Oasis Fashion Limited

6 February 2022

Observations

Exterior of the building

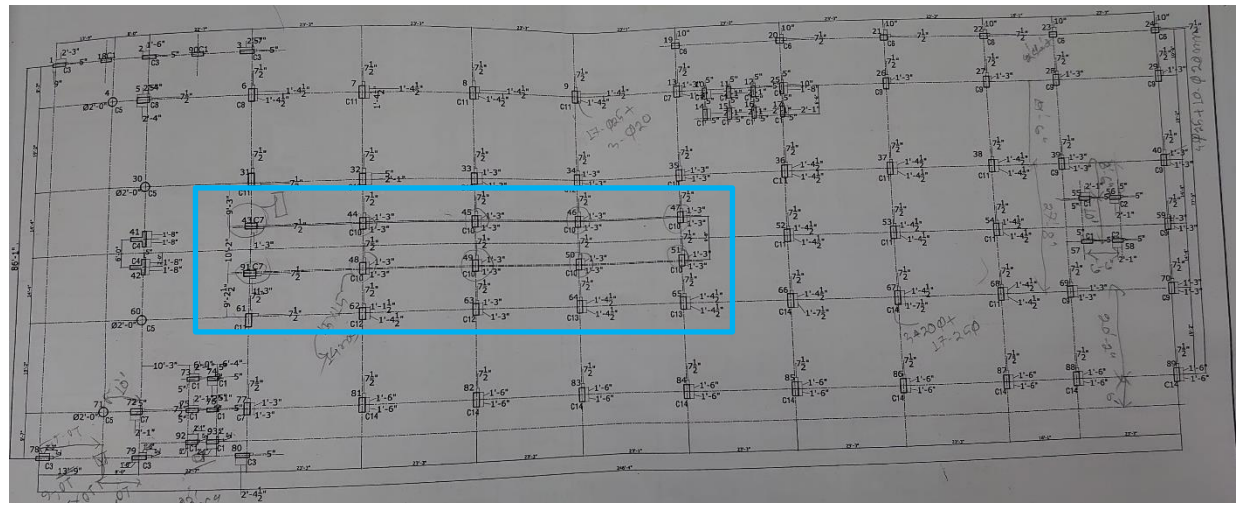
The building framing system (consists of RC columns & the flat plate) has no shear wall or other means to provide lateral stability against wind and seismic forces. The building engineer is required to check the lateral stability of the structure and provide necessary alternatives. Also, during the inspection, any design report was not available for this building which is required to be prepared in compliance with section 1.9.1 (part-6, BNBC).
